Recall Bulletin

F/CMVSS NONCOMPLIANCE RECALL

SUBJECT: Child Restraint Top Tether Anchor Not Accessible for Front Center Seating Position

**MODELS: 2004-2011 Chevrolet Colorado
2004-2011 GMC Canyon
Regular Cab, Extended Cab without Rear Seats
Equipped with a Front 60/40 Split Bench Seat**

2545047

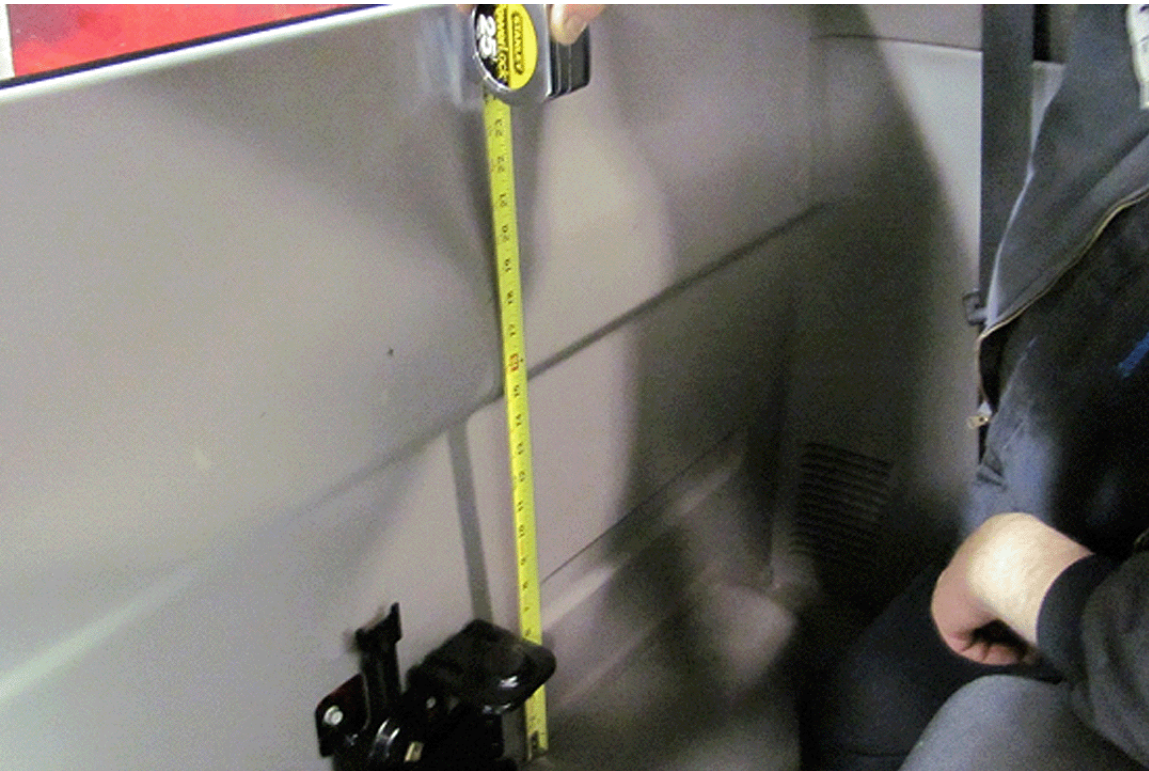
4. Remove the tether access cover. The cover is located on the passenger side of the vehicle.

2545048

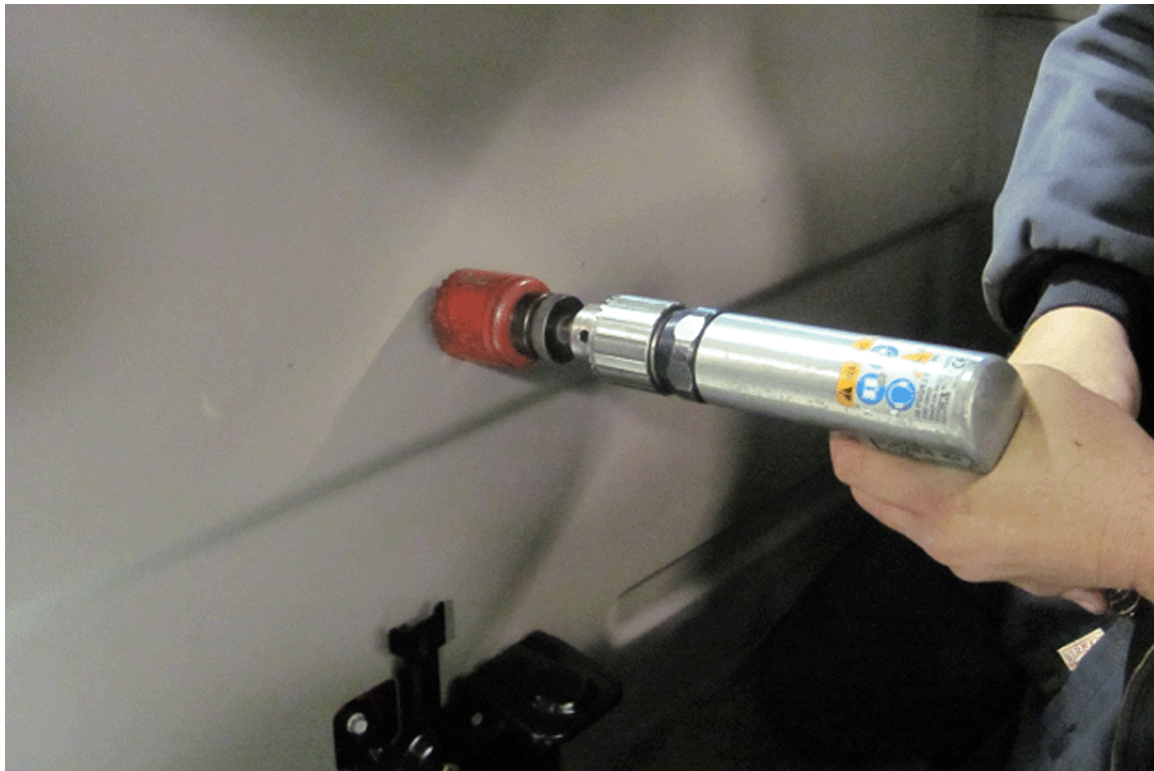
5. Using a tape measure and pen, measure 341 mm (13 7/16 in) from the inboard side of the tether access hole to the center of the second (center) tether access point. Mark the center of the hole with a pen.

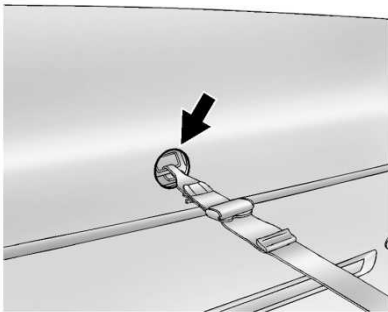
If you must transport a forward-facing child restraint in the center front seat position, you must have a hole in the back panel trim cover to allow access to the top tether anchor for that position. If your vehicle does not already have a hole, you must have a service procedure performed on your vehicle prior to securing a forward-facing child restraint in the center front seat position. Your GM dealer will cut a hole into the back panel trim cover to allow access to the top tether anchor for the front center seat position. This service procedure will be performed for you at no charge.

- 3.2. Attach the top tether to the slots in the back panel as shown. Do not tighten the top tether at this time.
4. Pick up the latch plate on the center position lap safety belt, and run the lap safety belt through the restraint. The child restraint instructions will show you how.
